Access Compliance Report

Public Rights-of-Way

(Pedestrian Signals)

Intersection ID: N/A	Main Street:	Cross Street: N/A	Location: N/A
ADA ID: 2C5B67926DB3	Signal Type: Two Push Buttons-APS	Overall Compliance: No	Severity Score: BTN 1:N/A BTN 2: N/A No BTN: N/A
Codes/Mitigation Info/Possible Solution		Field Measurements/Component Compliance

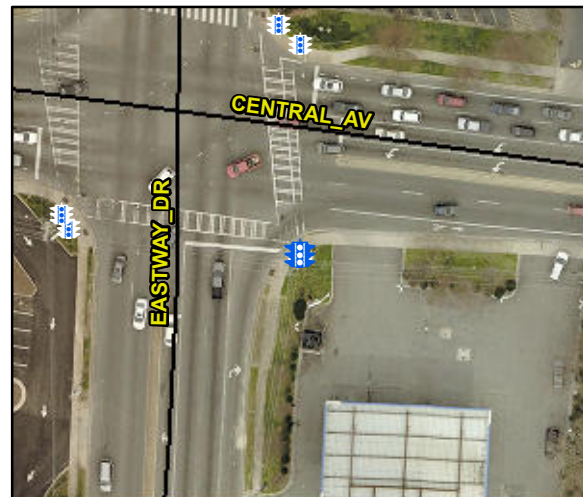
Surveyor Notes: TEXT HT 3/8

PROW/ADA: R410.6, R209.1, TMUTCD 4e.08, R406.2, R404.2, R404.3

Possible Solutions: Replace Signal Push Button With APS Button on New Post. Remove & Replace Sign.
